AMENDMENTS TO THE DRAWINGS

Please amend the drawings as described below. The “Annotated Sheet(s)” shows the changes in red ink. The associated “Replacement Sheet(s)” corresponds to the description of the amendments appearing below.

Serial No. 10/645,566
ANNOTATED Sheet

FIG. 1
(RELATED ART)

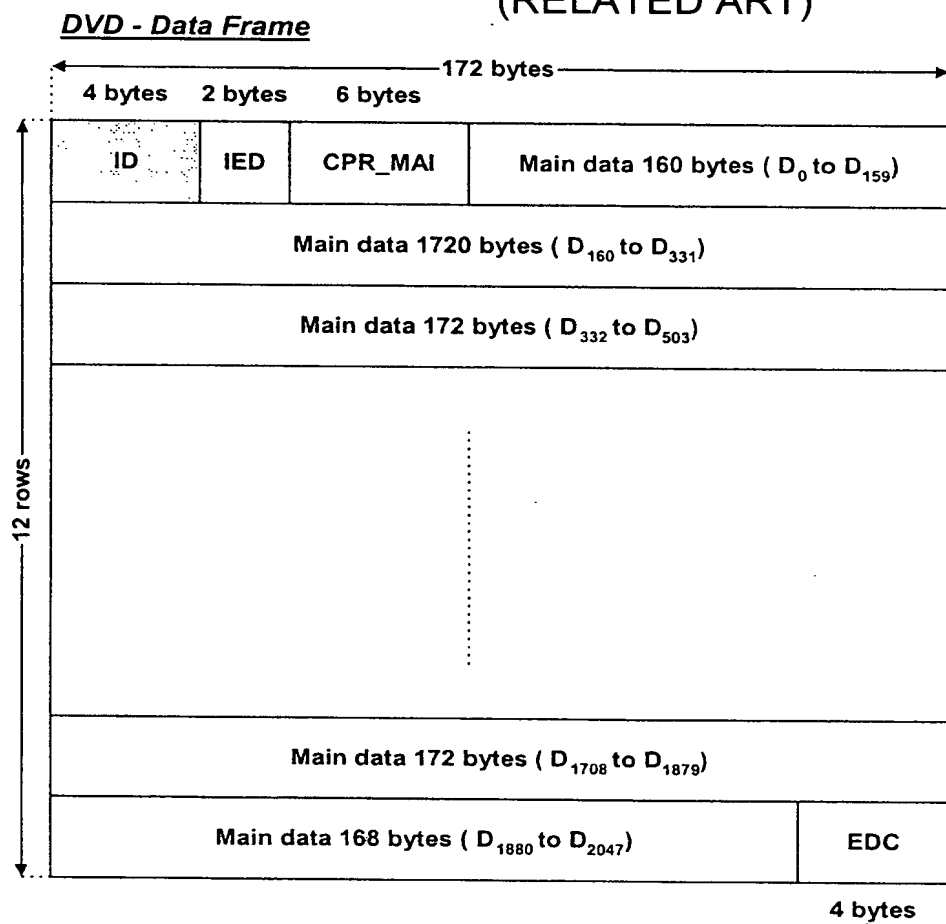
In FIGS 1-2, the legend “Related Art” has been added.

FIG. 8

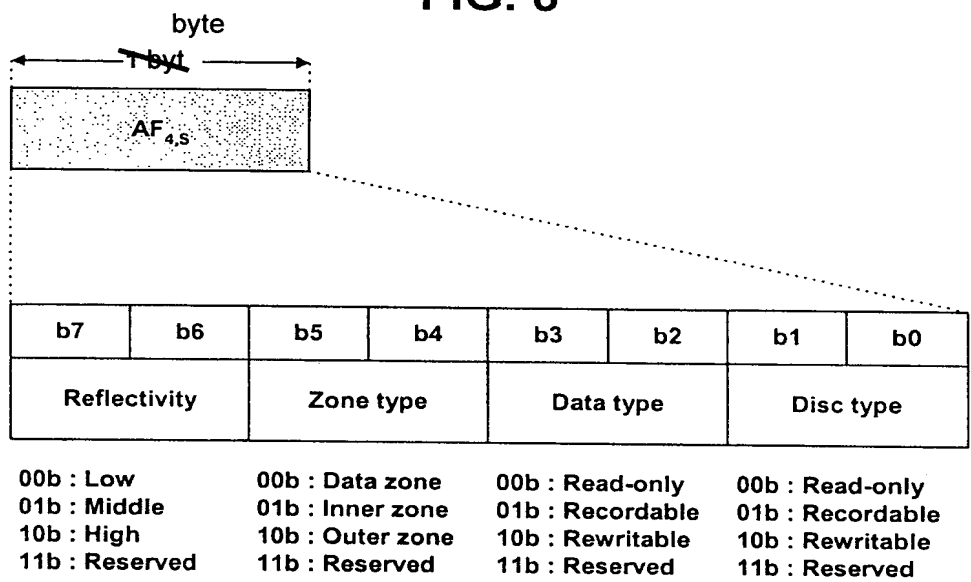
In FIG 8, the label “byt” has been changed to --byte--.
